Subject: Request for guidance on EUI vs OUI

802.17 has received the following comments (415 & 363) during its WG ballot on Draft 2.5 of RPR:

Sincerely,
Michael Takefman, Chair IEEE 802.17 Resilient Packet Ring Working Group

Figure 11.10—OAM organization specific frame format

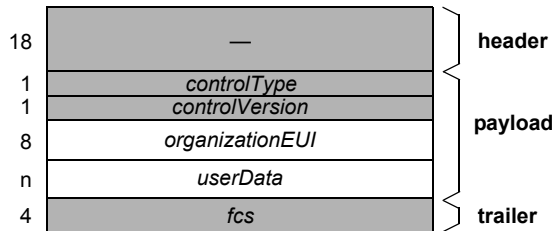
RPR OAM and Topology currently use the EUI-64 as a vendor specific protocol identifier. However, the EUI-64 was intended as a globally unique identifier. Further, IEEE 802 in Clause 9 defines the use of OUI as a vendor specific protocol identifier and not EUI. As a result, OUI should be used to align with other 802 standards.

In addition, according to "Guidelines for EUI64: 64-bit Global Identifiers," no more than one EUI-64 value shall be contained within each component that is manufactured. This restriction would prevent an OAM-enabled system from speaking two or more separate organization specific protocols.

As a result, the usage of EUI is not appropriate.

The usage of EUI is currently in clause 11.6.4 and 10.11.4.8 of P802.17. These clauses are attached for your information.

Replace EUI-64 with OUI as defined by IEEE 802 Clause 9.
